Private Fuel Storage, LLC

DATA NEEDED FOR NRC REVIEW OF LICENSE AMENDMENT # 22
DOCKET NO. 72-22/TAC NO. L22462
PRIVATE FUEL STORAGE FACILITY
PRIVATE FUEL STORAGE L.L.C.

Enclosure 1

Response to NRC letter dated May 7, 2001

Figure SHA01-1 Fractile hazard curves for PGA

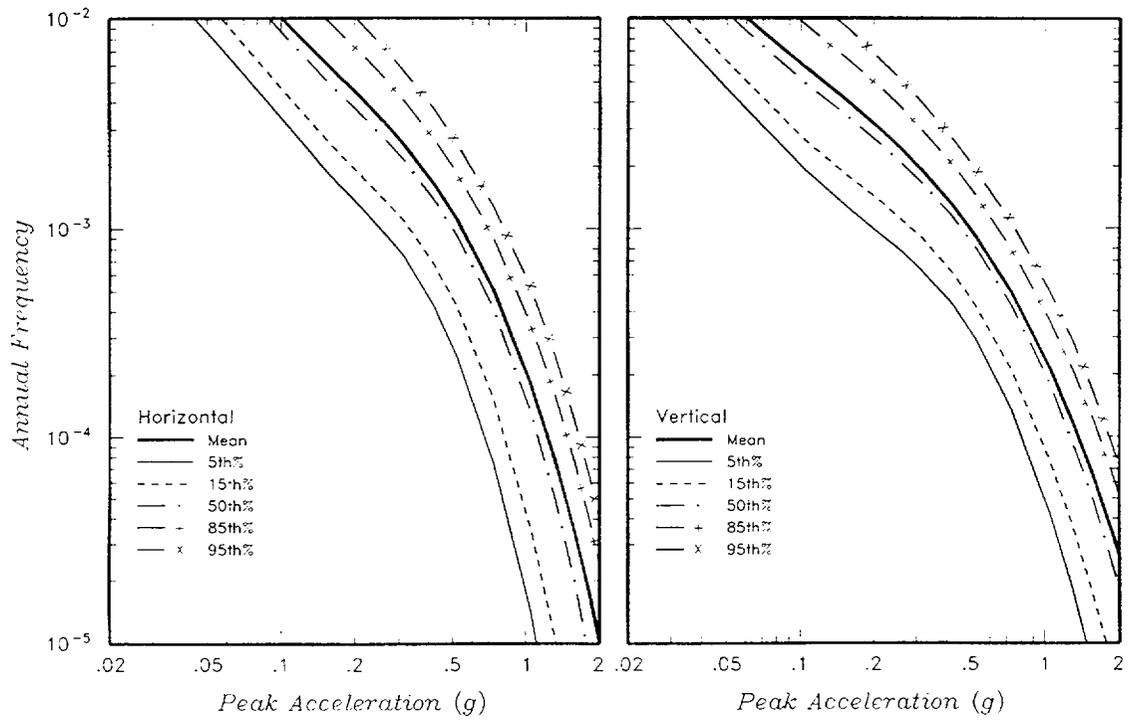
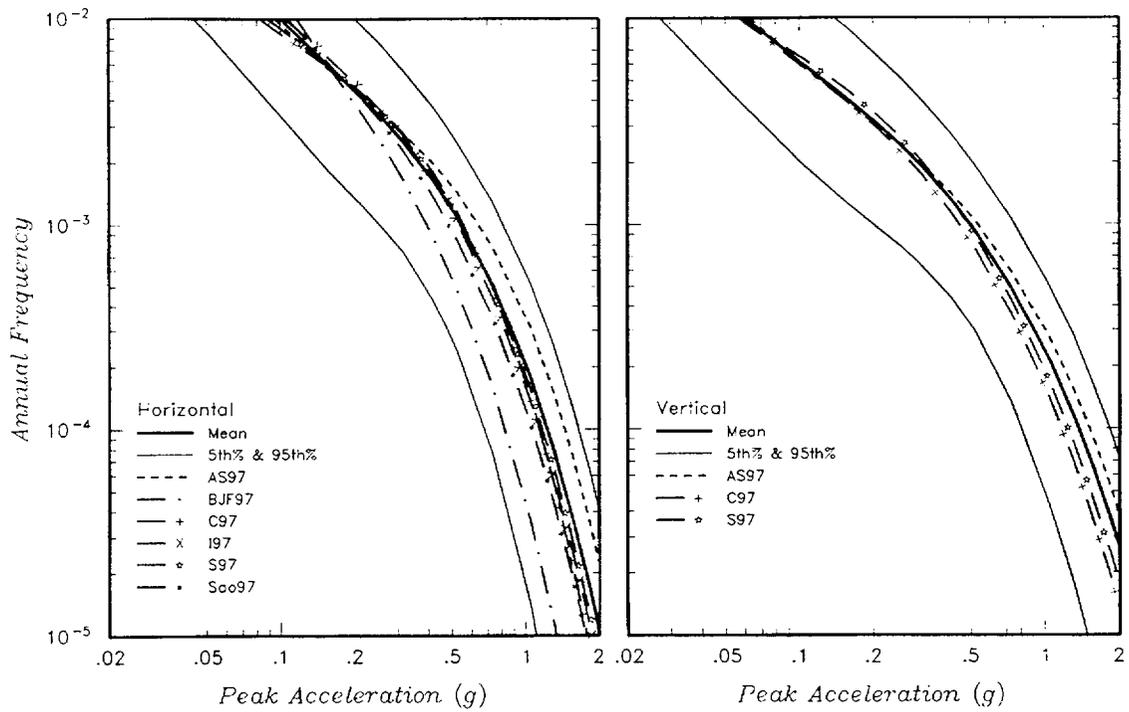
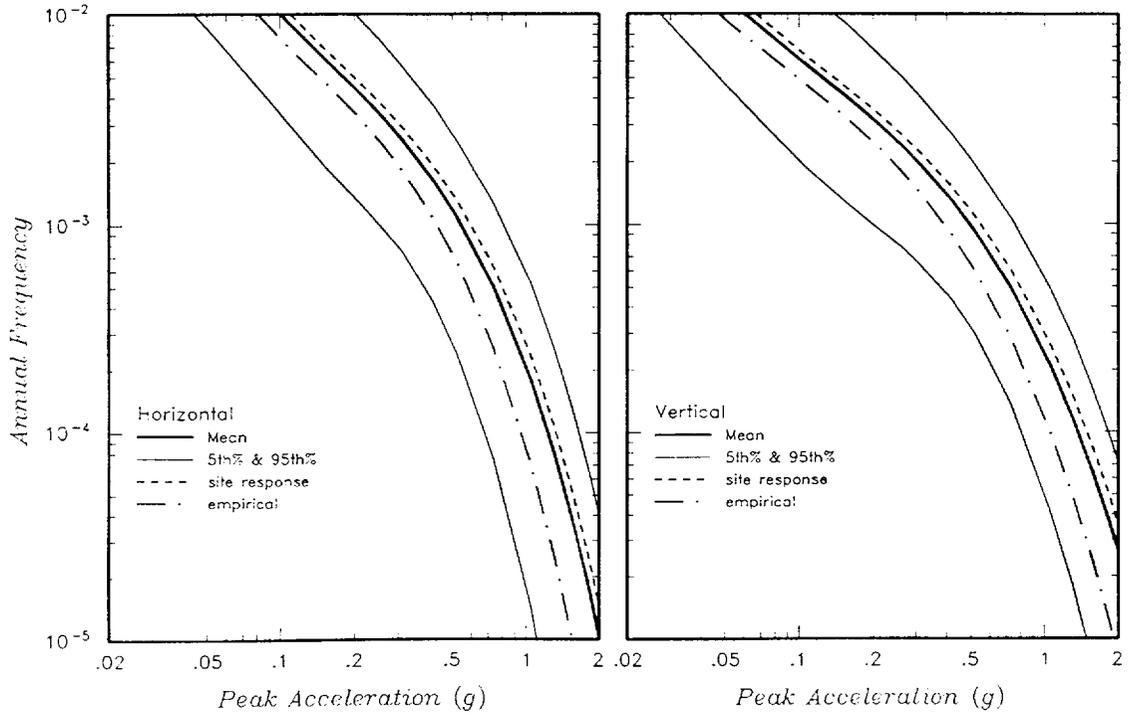
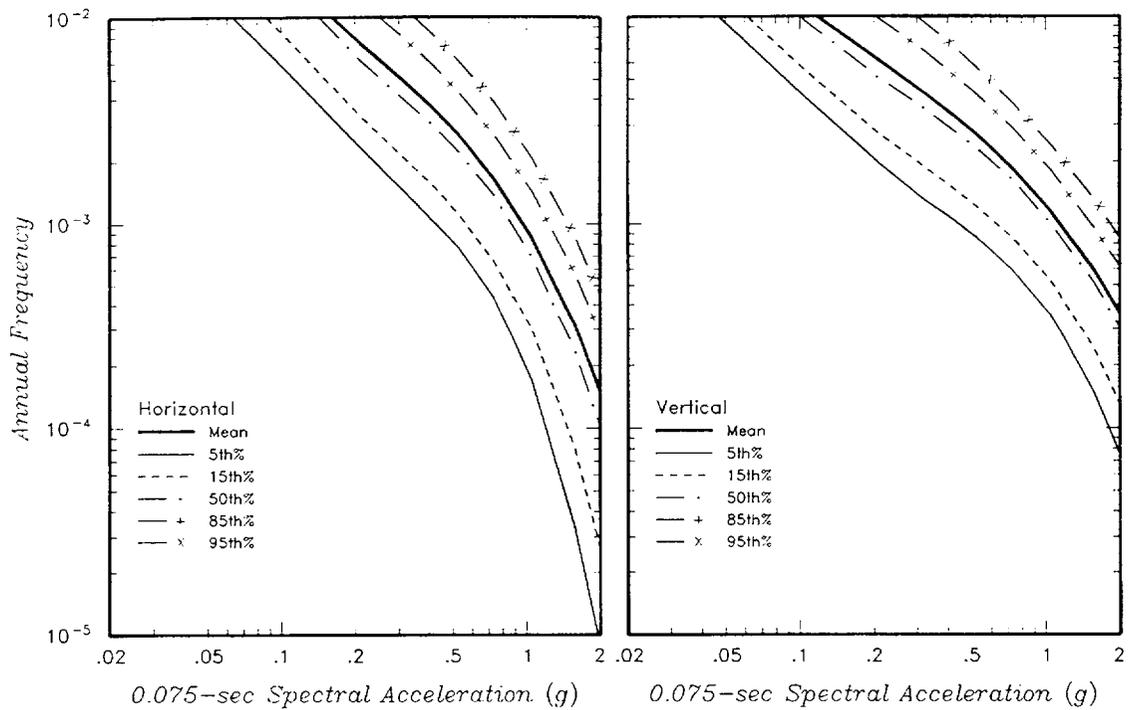
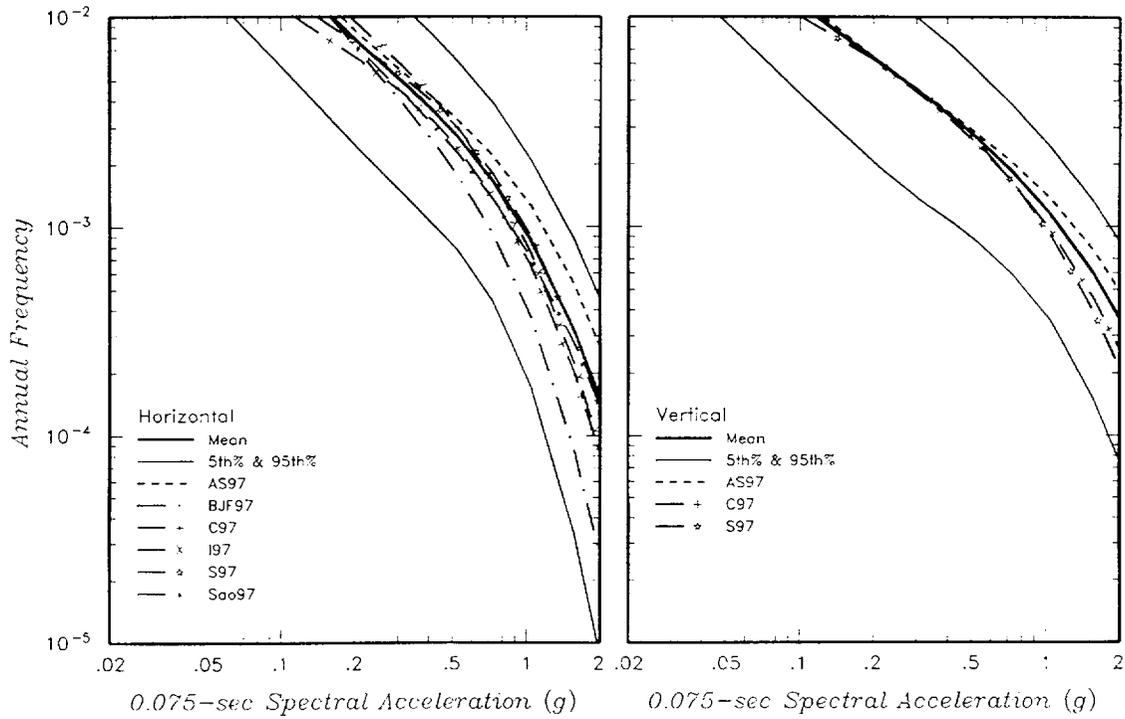
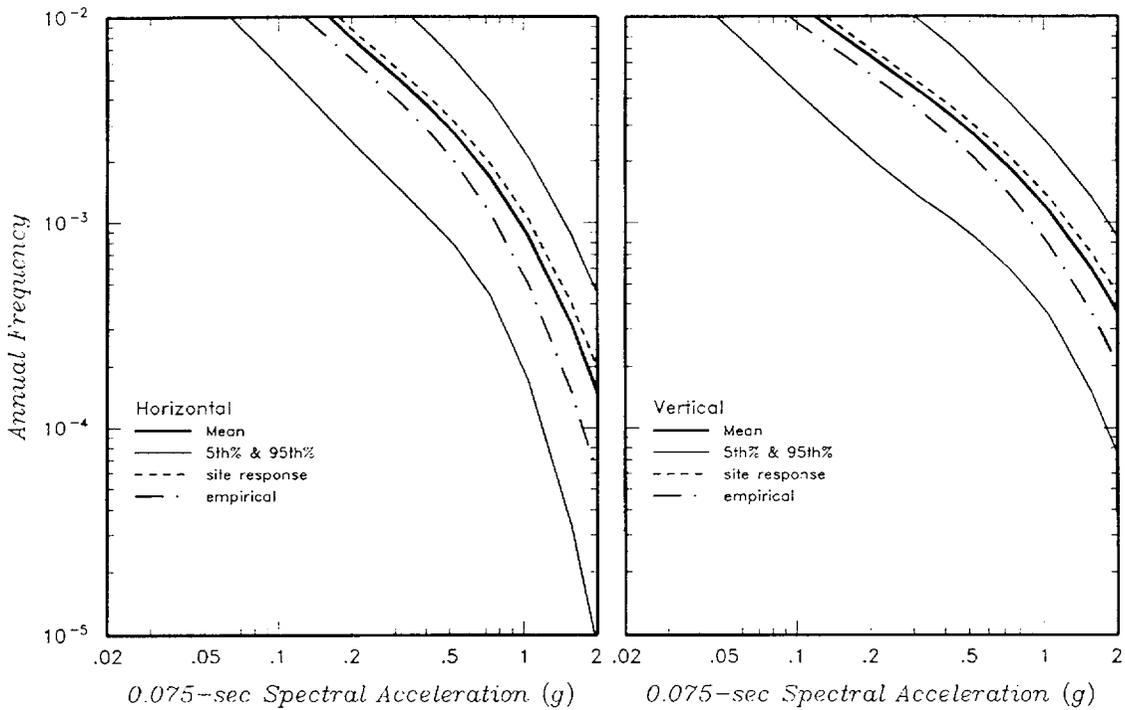
- 1. Deaggregated hazard curves (mean and fractiles) for horizontal and vertical ground motion for each attenuation and site response model at all 16 frequencies.**

The following series of figures illustrates the results in terms of the fractile hazard curves over all uncertainties and the condition mean hazard curves for specific cases. The first figure in each set of three shows the mean and fractile hazard curves over all uncertainties. The second figure shows the mean and 5th and 95th-percentile fractile hazard curves over all uncertainties and the conditional mean hazard curves for each attenuation relationship. The third figure shows the mean and 5th and 95th-percentile fractile hazard curves over all uncertainties and the conditional mean hazard curves for the two site factors based on empirical and site response approaches.

Figure SHA05d-1 Comparison of 2000-year equal hazard response spectra (5% damping) for generic California rock and deep soil site conditions (no site adjustment factors applied).

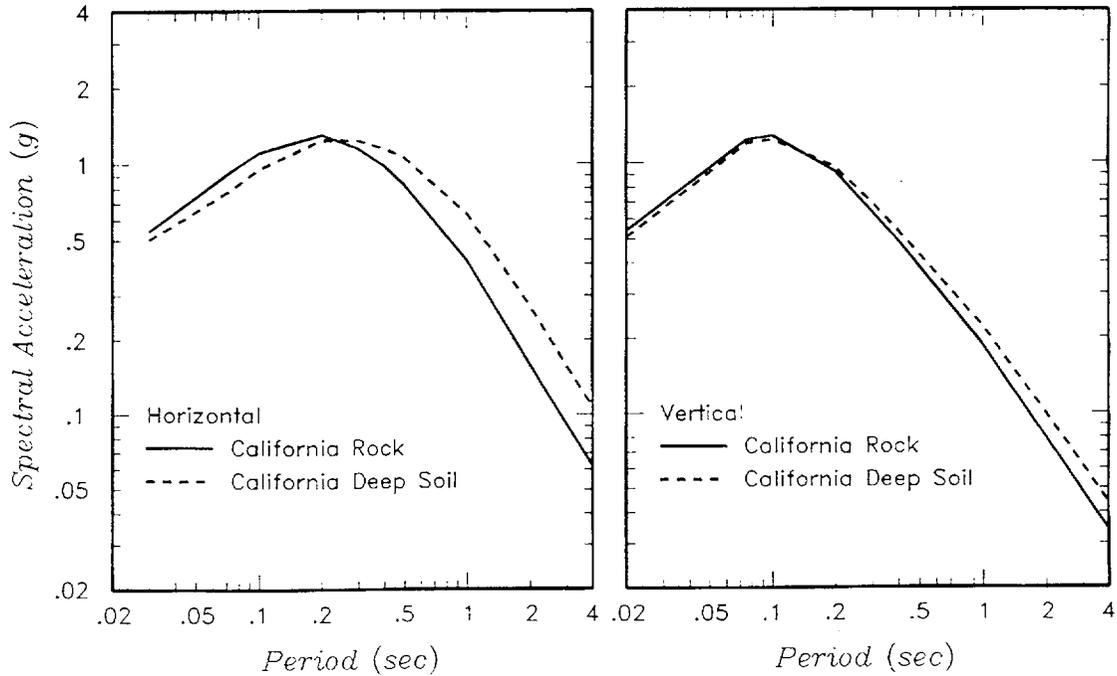
The effect of using rock attenuation relationships rather than soil attenuation relationships is illustrated by the following sensitivity analysis. Seismic hazard analyses were performed using the suite of rock and soil attenuation relationships without modification for local site conditions. The hazard results were used to construct 2,000-year return period response spectra for California rock and deep soil site conditions. These spectra are compared on Figure SHA05d-1. The change from soil to rock site motions results in

a slight increase in the high-frequency portion of the spectra and a decrease in the low frequency portion of the spectra.

Figure SHA05d-2 Comparison of the 1999 design spectra based on California deep soil attenuation relationships and the 2001 design spectra based on California rock attenuation relationships

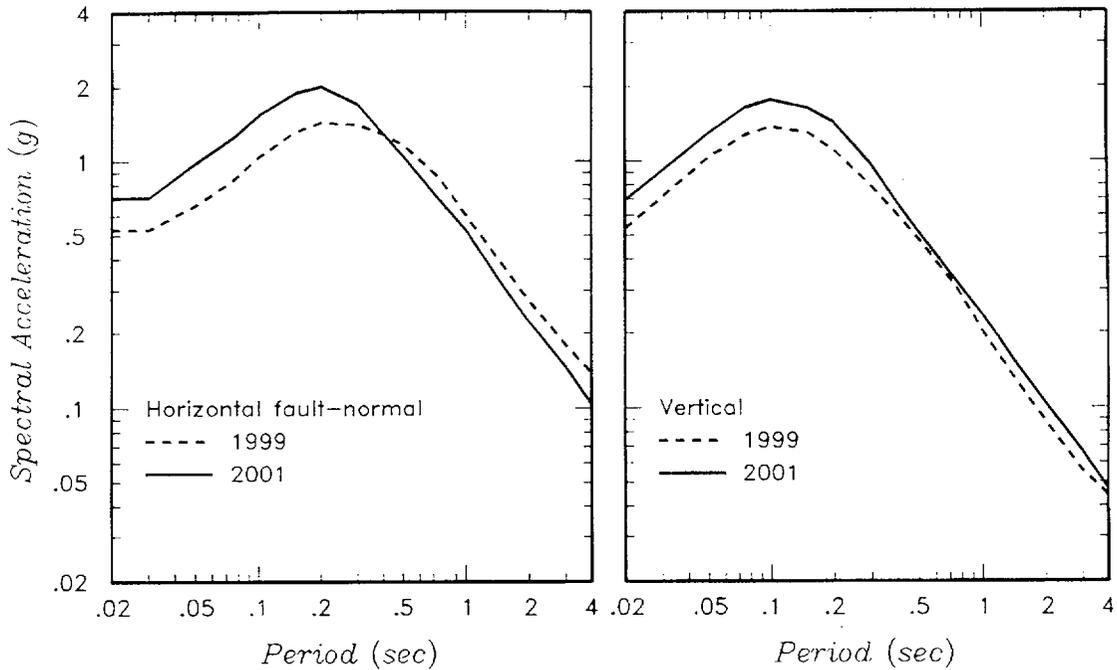
Figure SHA05d-2 compares the PFS site-specific design response spectra developed in 1999 based on California deep soil attenuation relationships to the revised design response spectra developed in 2001 based on California rock attenuation relationships. In both the horizontal and vertical directions, the revised design spectra are significantly higher than the 1999 design spectra for spectral periods less than about 0.3 seconds (frequencies greater than about 3 Hz). At longer periods the revised horizontal spectrum is somewhat lower than the 1999 horizontal spectrum while the revised vertical spectrum is slightly higher than the 1999 vertical spectrum. As indicated in Figure SHA05d-1, the difference between the ground motions for generic California rock and soil site conditions is small at short periods, becoming larger for horizontal motions at spectral periods greater than about 0.3 seconds. These comparisons suggest that the revised site-adjustment factors for the PFS site have a measurable impact in yielding higher horizontal accelerations for the short periods (high frequencies). This impact is significantly greater than what the shift from California soil to rock attenuation relationships would in itself produce.

Figure SHA05e-1 Effect of weights assigned to site response factors on 2000-year equal hazard response spectra (5% damping)

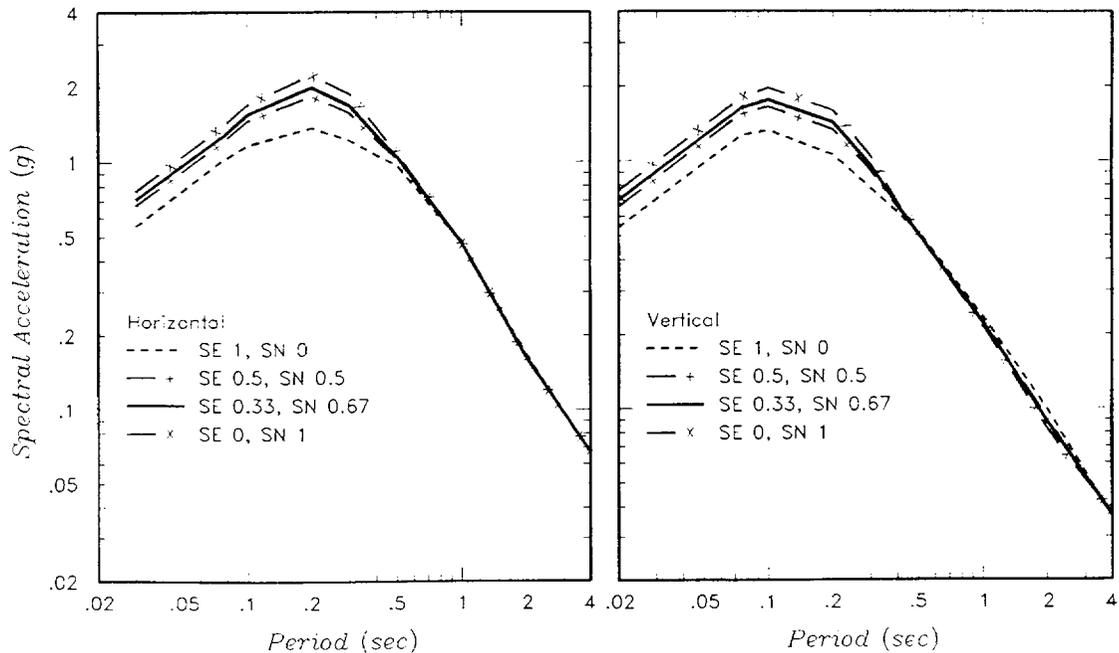
As described in Appendix F of the revised seismic hazard analysis report, two alternative approaches were used to develop site adjustment factors to modify California rock site attenuation relationships to the site conditions at the Skull Valley PFSF site. One approach was based on relative site response analyses (designated SN in this response) and one was based on empirical strong motion data (designated SE in this response). The site hazard was computed assigning a weight of 0.67 to the site response approach and a weight of 0.33 to the empirical approach. To examine the sensitivity of the results to these weighting factors, the hazard analyses were repeated using a range of weighting alternatives. The following table lists the resulting 2,000-year return period equal-hazard response spectral accelerations (5% damping). These spectra are shown on Figure SHA05e-1.

The design ground motion spectra are sensitive to the relative weights assigned to the empirical and site response site adjustment factors for spectral periods less than about 0.5 seconds (spectral frequencies greater than about 2 Hz).

Figure SHA08-11 Comparison of relative site response spectral ratios for the base case and alternative shear wave velocity profiles

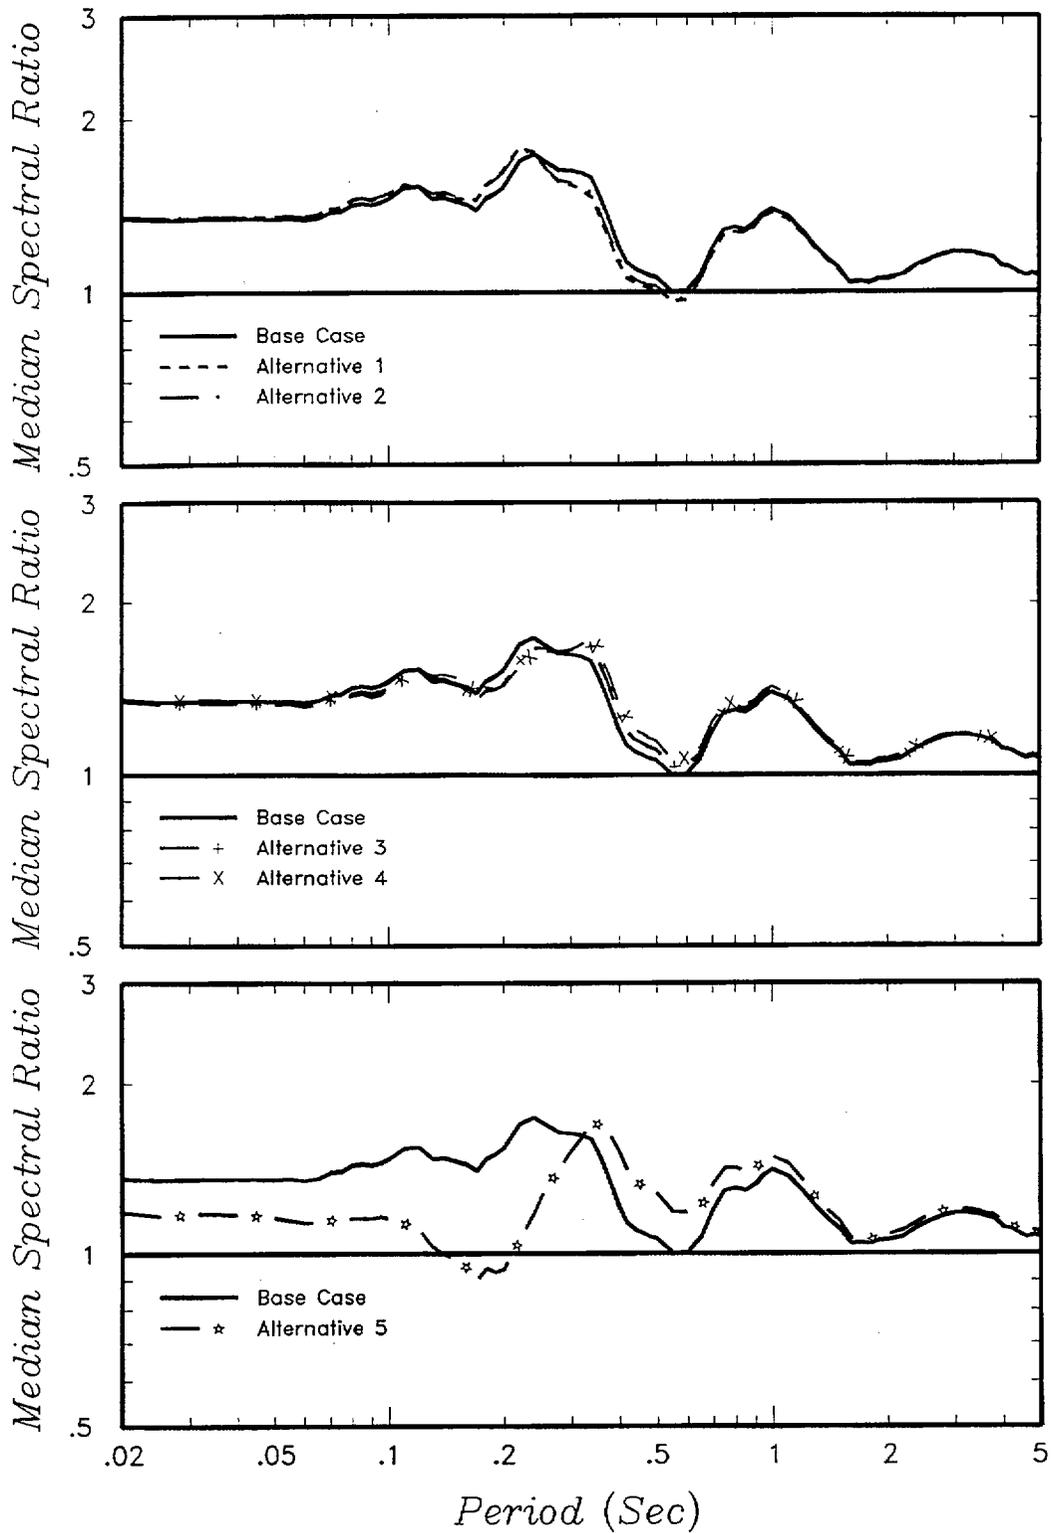
- 8. More site specific data (i.e., beyond the one existing deep well) for the soil between 30 ft and the Tertiary strata or provide an analysis that shows that the applicant has captured the uncertainty of the soil properties sufficiently such that any new information will not again significantly change the ground motions (i.e., sensitivity study of the site response model that would incorporate the variability of the soil parameters expected for this site).**

For each of the six analysis cases, the base case and the five alternative profiles, 240 site response analyses were conducted using the 24 input time histories developed in Appendix F of Geomatrix (2001a). The response spectra for the computed surface motions were divided by the corresponding spectra for a WUS rock site. The median (mean-log) of the 240 spectral ratios was then computed. Figure SHA08-11 compares these spectral ratios. The spectral ratios obtained using Alternative Profiles 1 through 4 show only minor differences from the base case results. Alternative 5 results in a large change in the computed spectral ratios. These results indicate that the details of the velocity profile in the upper 30 feet of soil (where the lowest velocities are experienced) are much more significant to the computation of relative site response than those below 30 feet (where the higher velocities are experienced), and that for levels below 50 feet the details of the velocity distribution assumed have little effect on the predicted relative site response.
